## The Progress Power (Gas Fired Power Station) Order

# APPLICATION TO MAKE A NON MATERIAL CHANGE TO THE PROGRESS POWER (GAS FIRED GENERATING STATION) ORDER

**PINS Reference Number:** EN010060  
**Document Reference:** NMC  
**Regulation Number:** Regulation 4  
**Author:** Progress Power Limited

Title: GAS TURBINE GENERATOR PLAN & ELEVATIONS Reg5(2)(o)

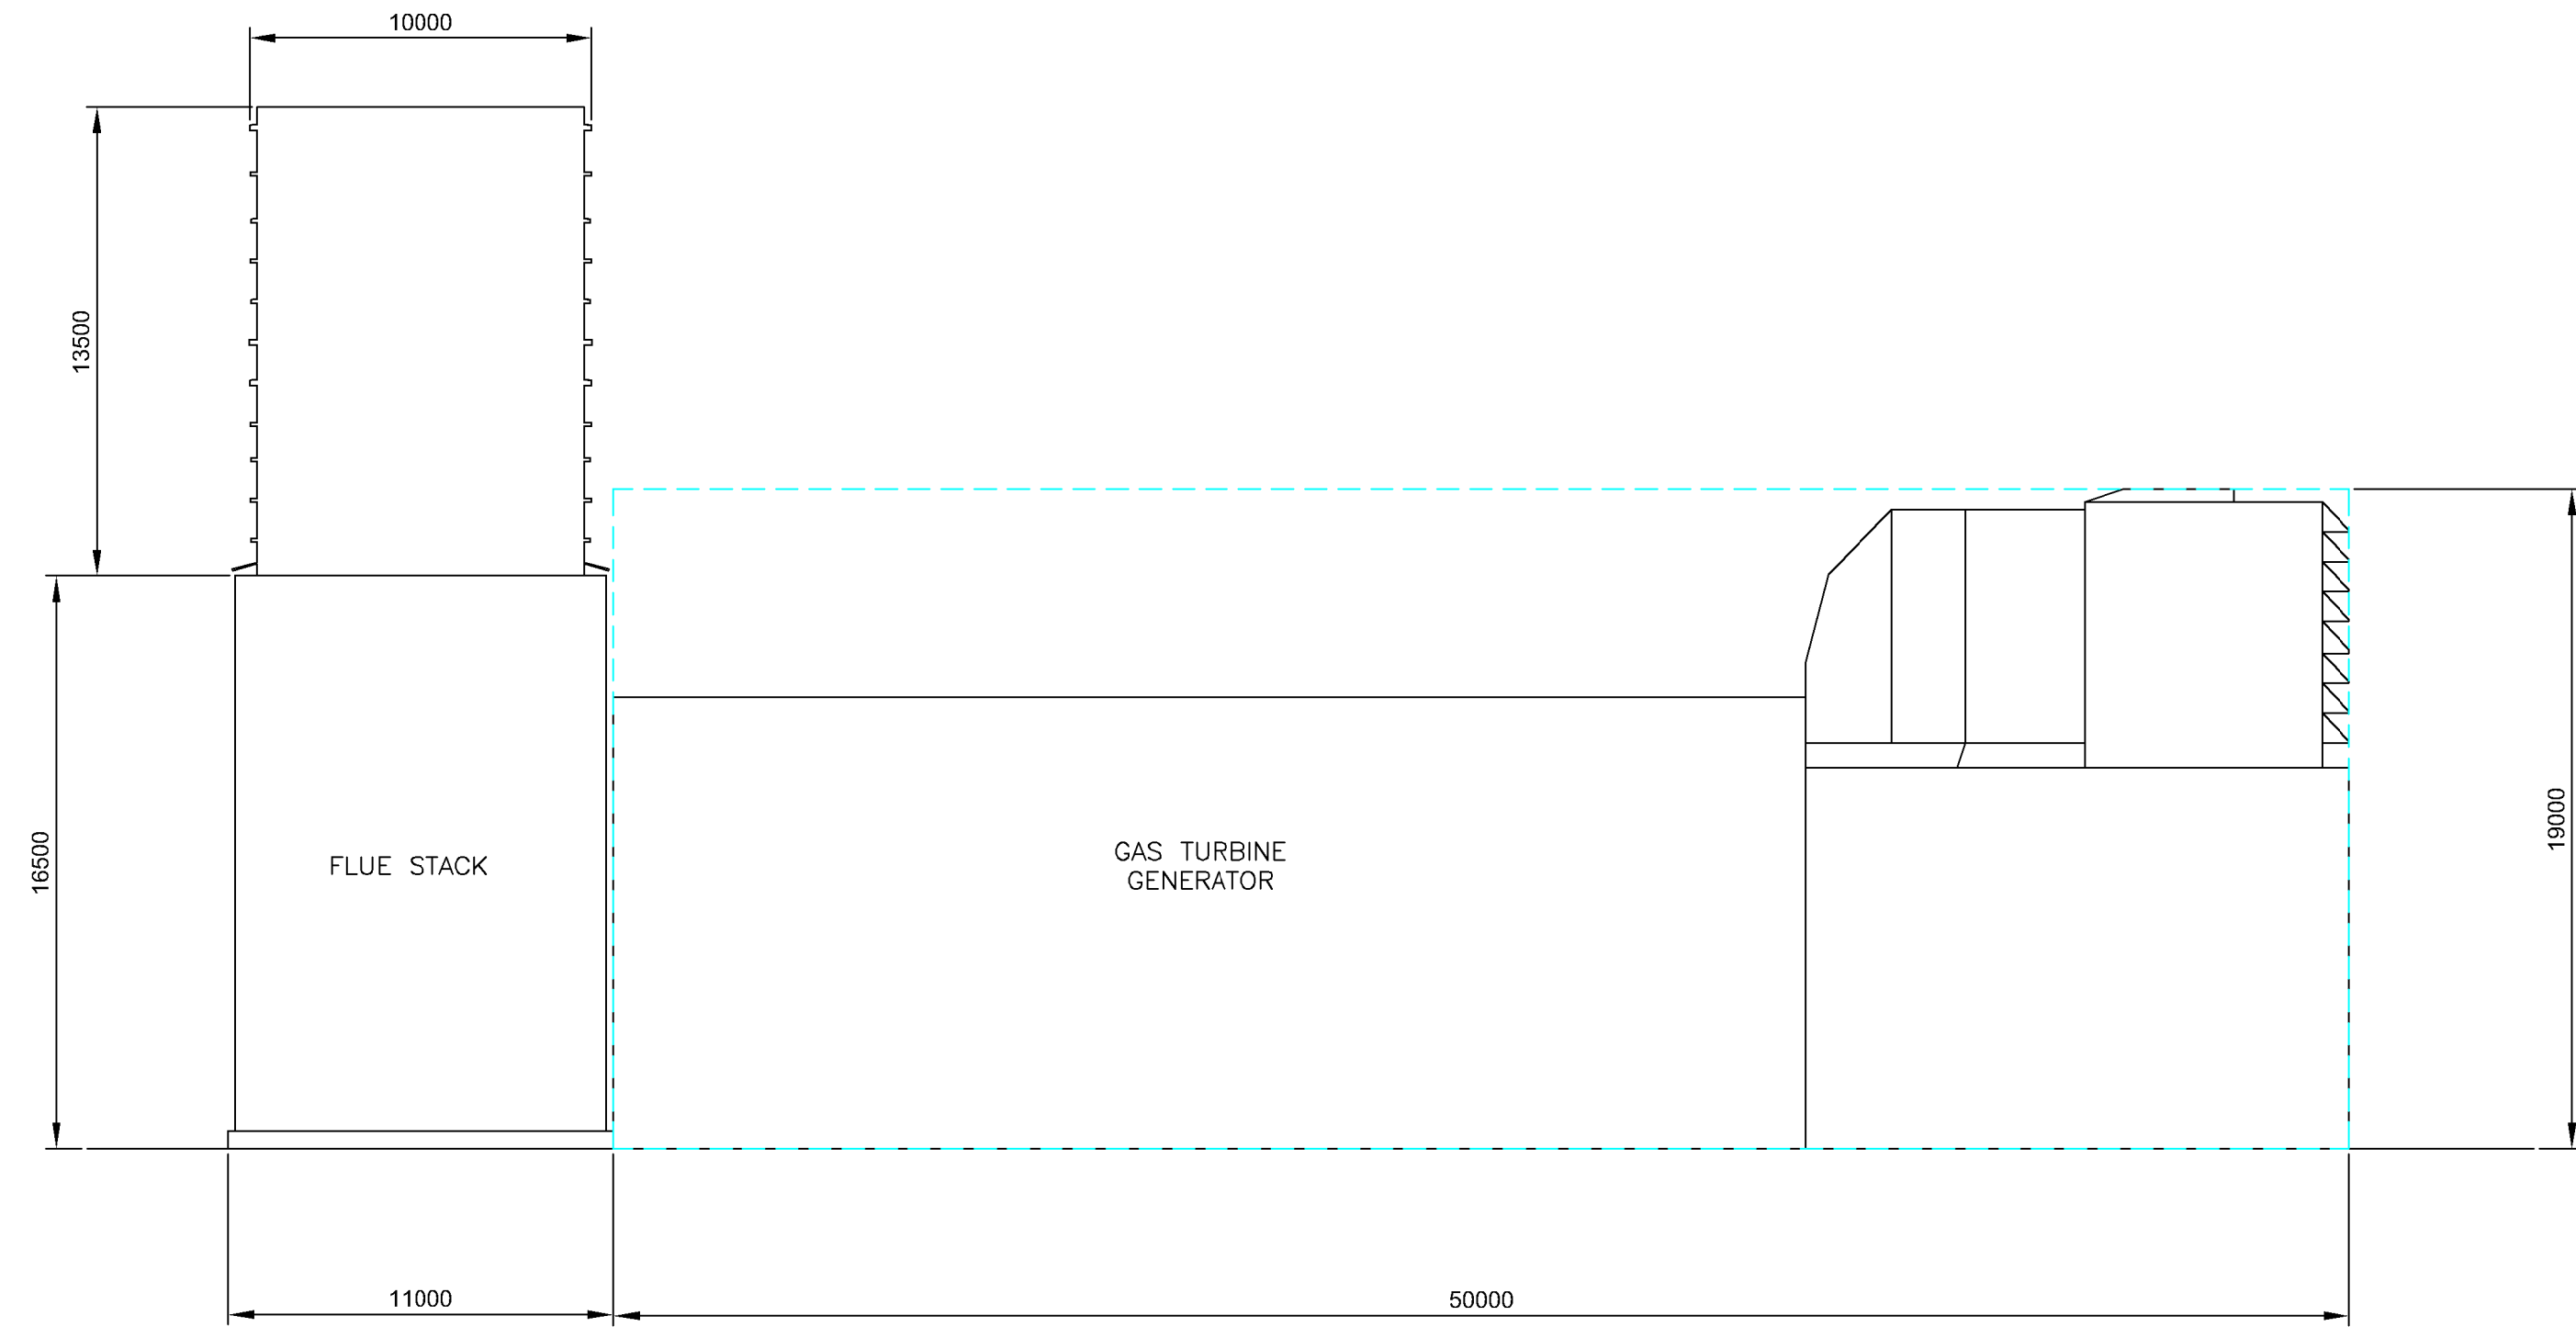
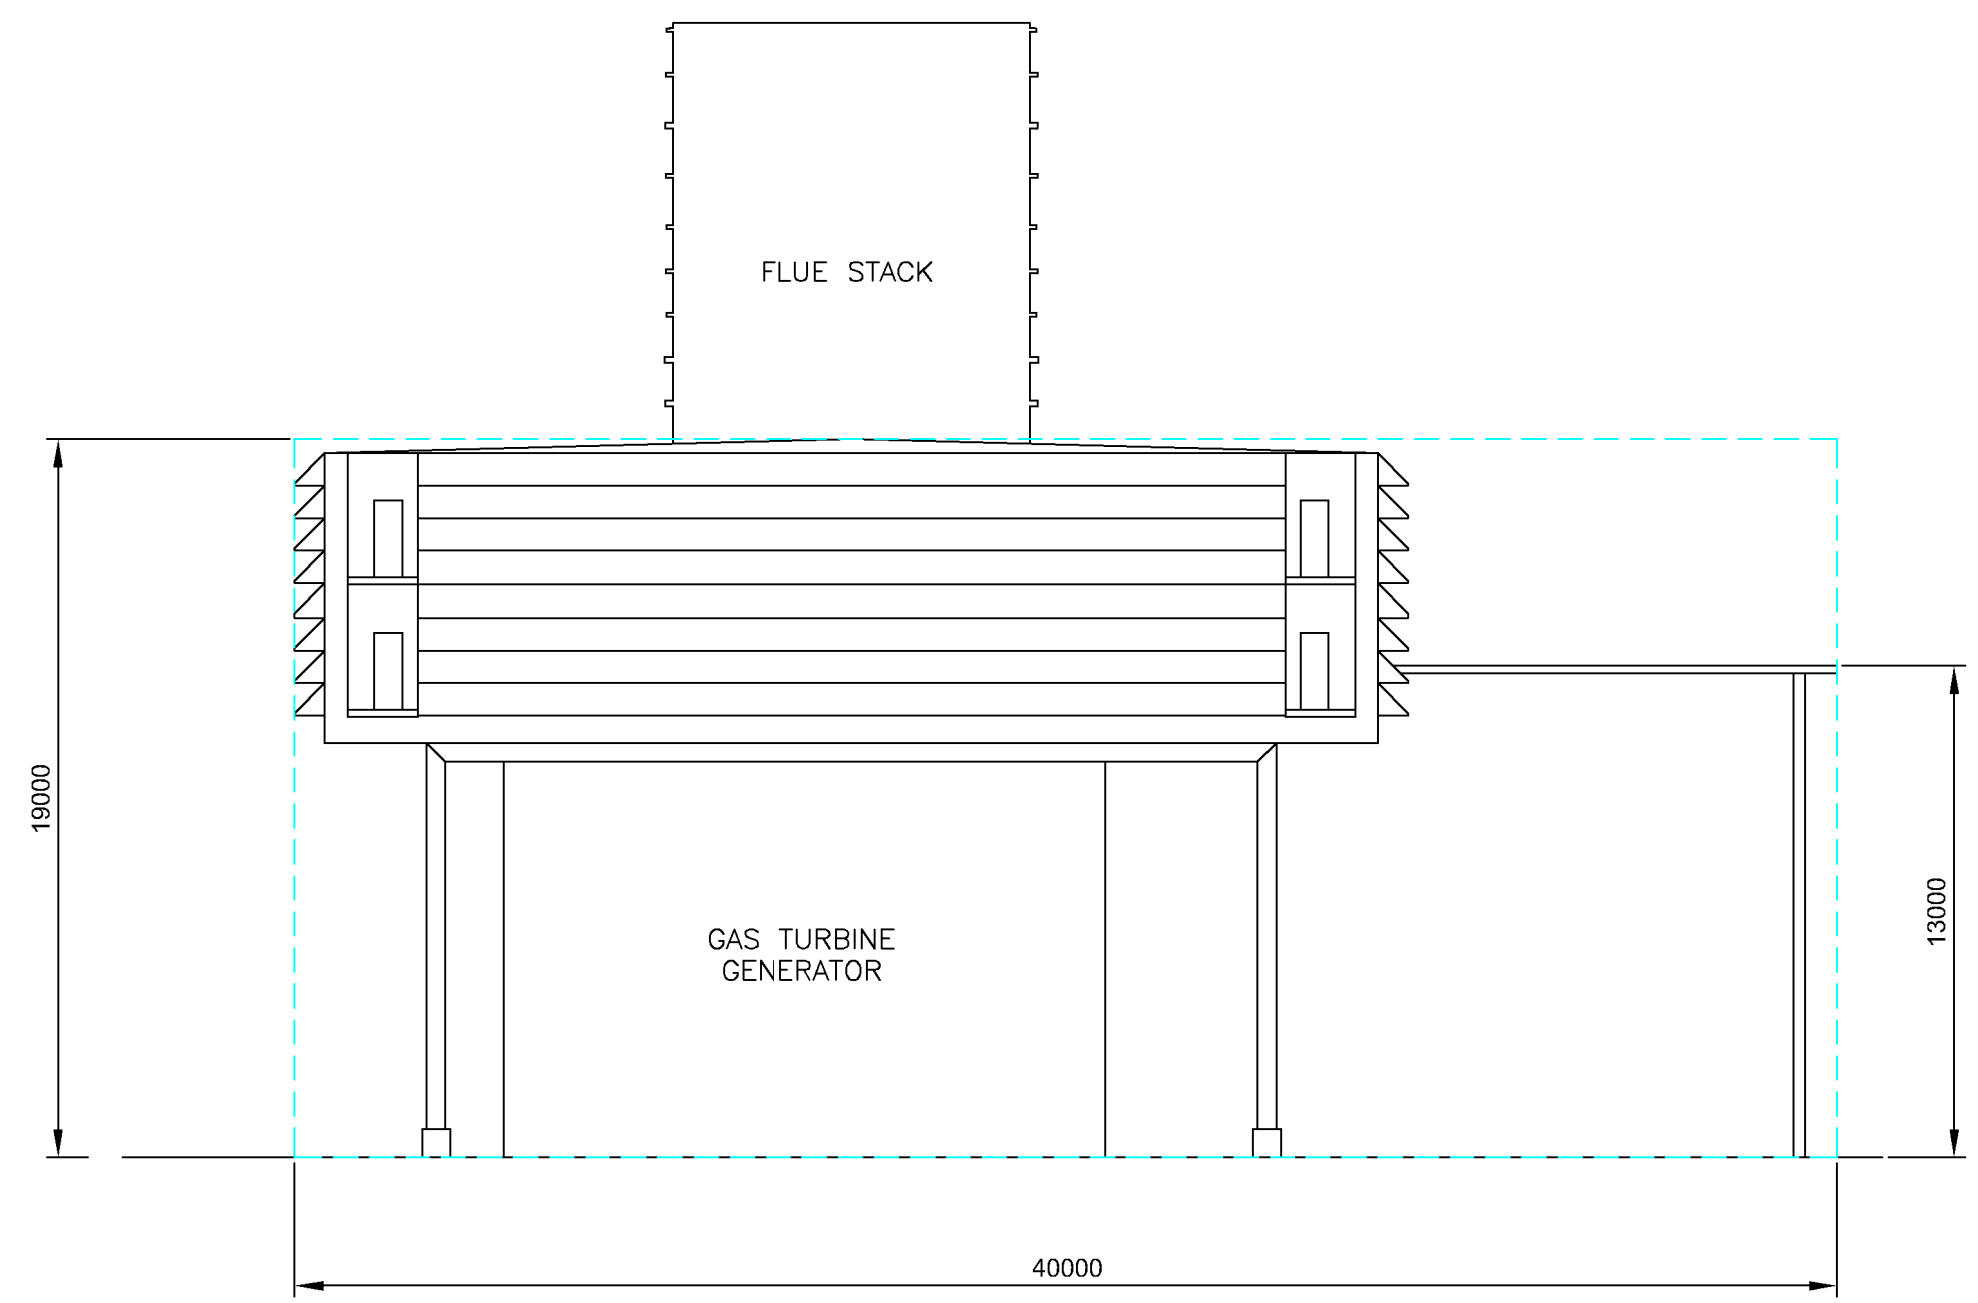
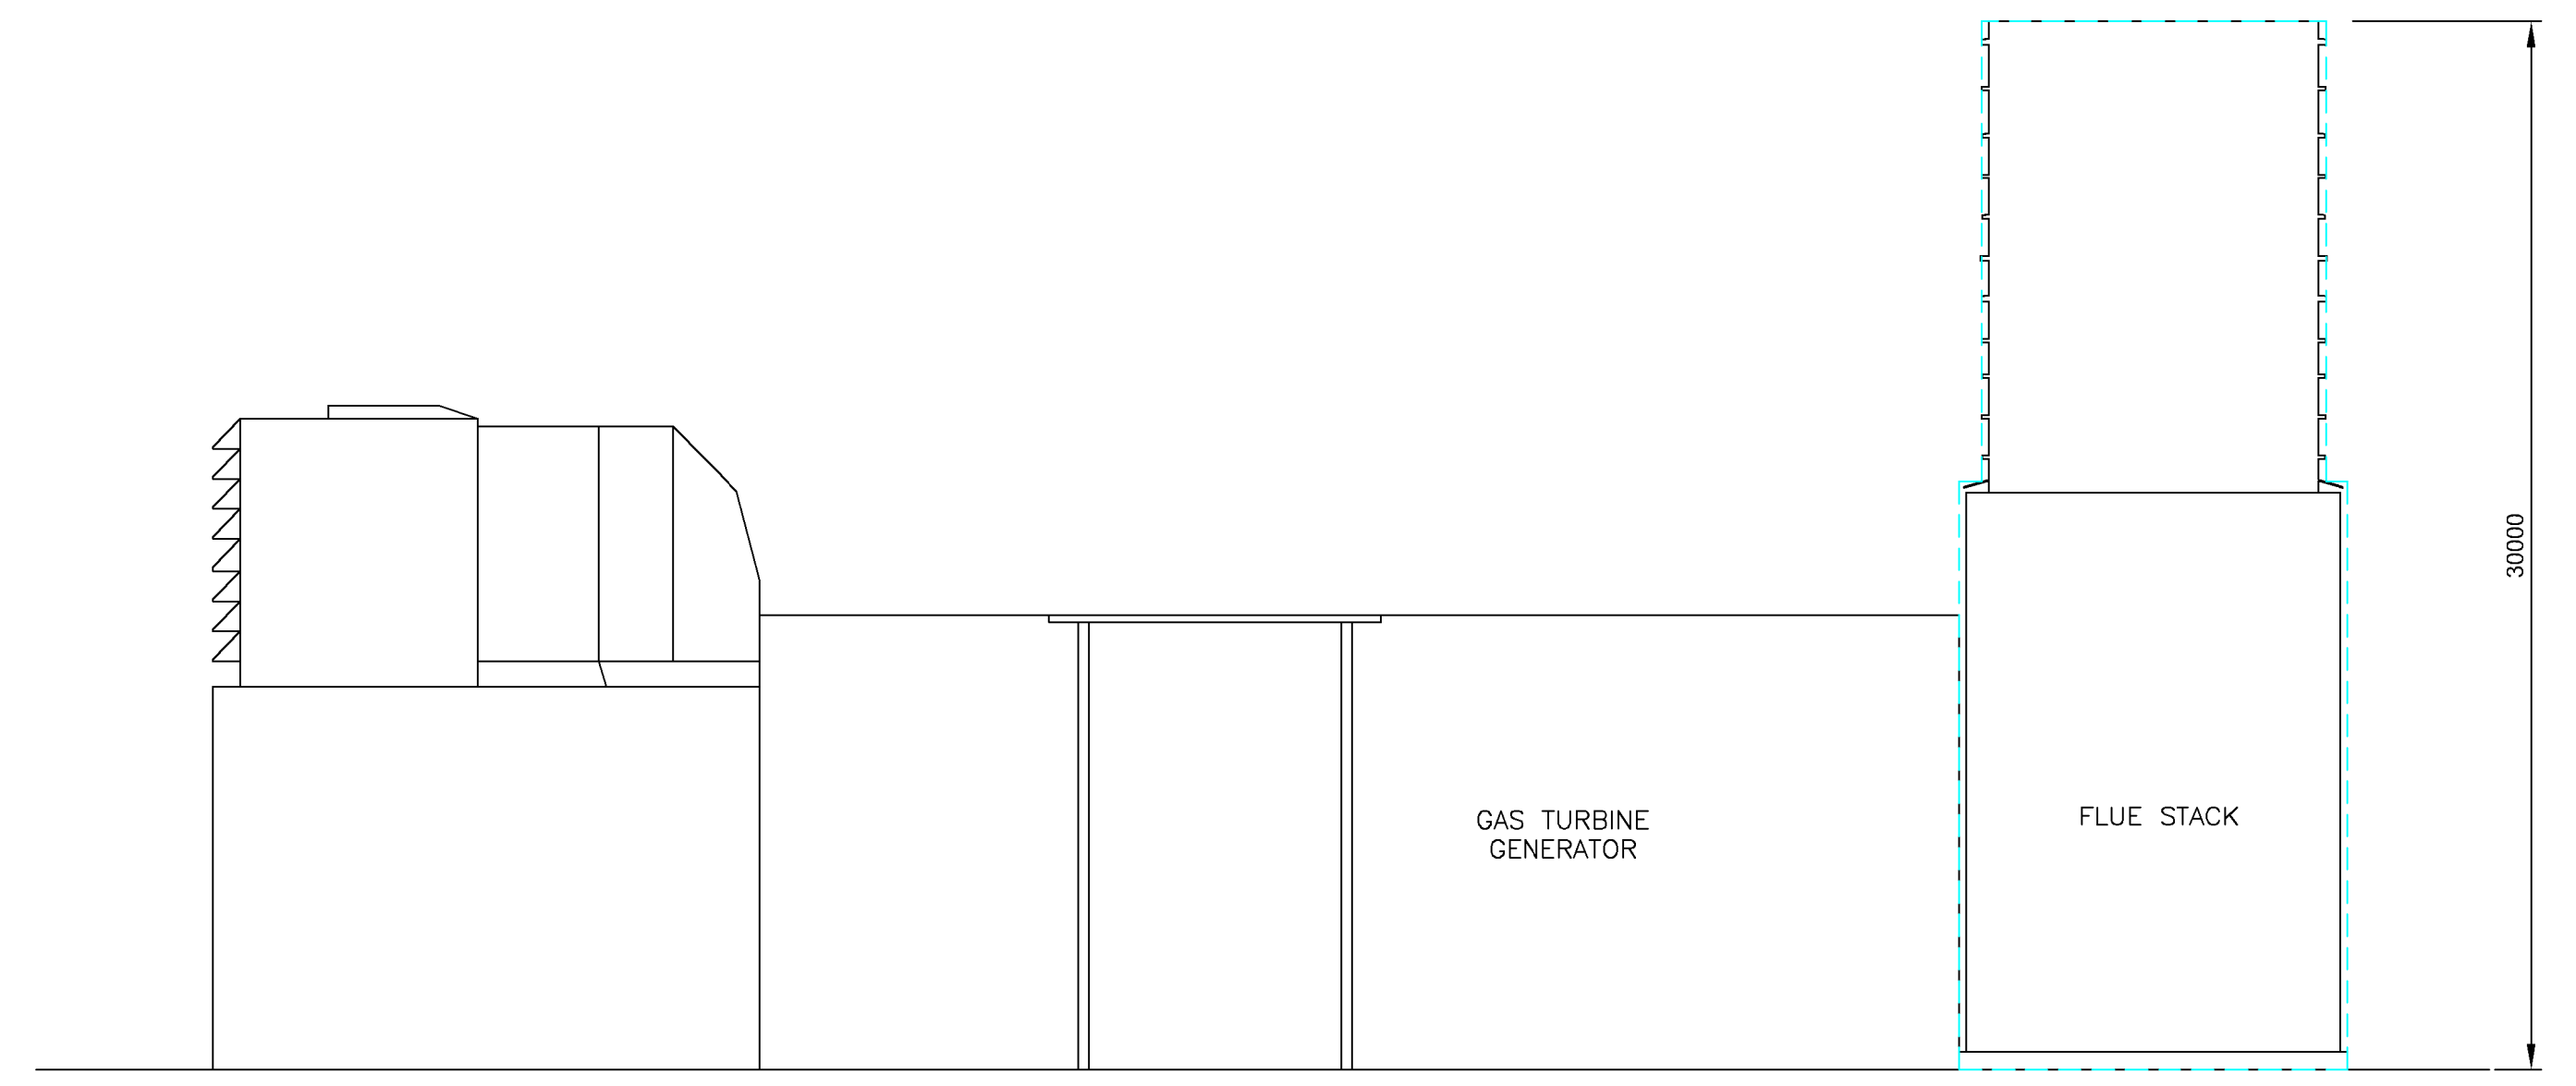
4.2.3 In summary, for **the one GTG solution only**, there is a need to increase the length of the GTG from a maximum of 30 metres to 50 metres to accommodate the diffuser system elements of the GTG and the width from a maximum of 30 metres to 40 metres to accommodate the lube oil system. This would involve a change to Table 2 in Requirement 3, Schedule 2 of the Order. However, there would be no change in the overall footprint of the Power Generation Plant as

4.3.2 At present, the Order does not account for this difference in width between the two sections of the flue stack. Accordingly, there is a need to increase the width of the flue stack from 8.4 metres to 11 metres up to and including a height of 16.5 metres AOD and from 8.4 metres to 10 metres thereafter to a height of 30 metres. The increase in the stack width for the upper section is required to enable the GTG to meet the noise limits under the Development Consent Order through the inclusion of a silencer. This would involve a change to Table 2 in Requirement 3, Schedule 2 of the Order.

Change Number	Building or Structure	Summary of what is currently authorised under the Order	Suggested Change
One	Gas Turbine Generator (GTG)	<p>Table 2, Requirement 3, Schedule 2:</p> <p>Each gas turbine generator (where one or two gas turbine generators are constructed) (Part of numbered work 1A):</p> <p>Maximum height: 19 metres above 48.5 metres AOD</p> <p>Maximum length: 30 metres</p> <p>Maximum width: 30 metres</p>	<p>Amend Table 2, Requirement 3, Schedule 2 as set out in Appendix Four so as to permit the following parameters for a single GTG scenario:</p> <p>Maximum height: 19 metres above 48.5 metres AOD</p> <p>Maximum length: 50 metres</p> <p>Maximum width: 40 metres</p>
Two	Flue Stack	<p>Table 2, Requirement 3, Schedule 2:</p> <p>Each exhaust gas emission flue stack (where one or two gas turbine generators are constructed) (part of numbered work 1A):</p> <p>Maximum height: 30 metres above 48.5 metres AOD</p>	<p>Amend Table 2, Requirement 3, Schedule 2 as set out in Appendix Four so as to permit the following parameters for a single GTG scenario:</p> <p>Maximum Width: 11.0 metres up to and including a height of 16.5 metres above 48.5m AOD and 10 metres from a height of</p>

Change Number	Building or Structure	Summary of what is currently authorised under the Order	Suggested Change
		<p>Minimum height: 25 metres above 48.5 metres AOD</p> <p>Maximum width: 8.4 metres</p>	<p>16.5 metres above 48.5m AOD to a height of 30 metres above 48.5m AOD.</p>
Three	Black start diesel generator	<p>1. Schedule 1:</p> <p>Numbered work 1B authorises development comprising....(e) black start diesel generator</p> <p>2. Table 2, Requirement 3, Schedule 2:</p> <p>Black start diesel generator (part of numbered work 1B):</p> <p>Maximum height: 5.0 metres above 48.5 metres AOD</p> <p>Maximum length: 13.0 metres</p> <p>Maximum width: 5.0 metres</p>	<p>1. Amend Schedule 1, Numbered work 1B(e) as set out in Appendix Three.</p> <p>2. Amend Table 2, Requirement 3, Schedule 2 as set out in Appendix Four so as to permit the following parameters for all GTG scenarios:</p> <p>Maximum length: 17 metres</p>
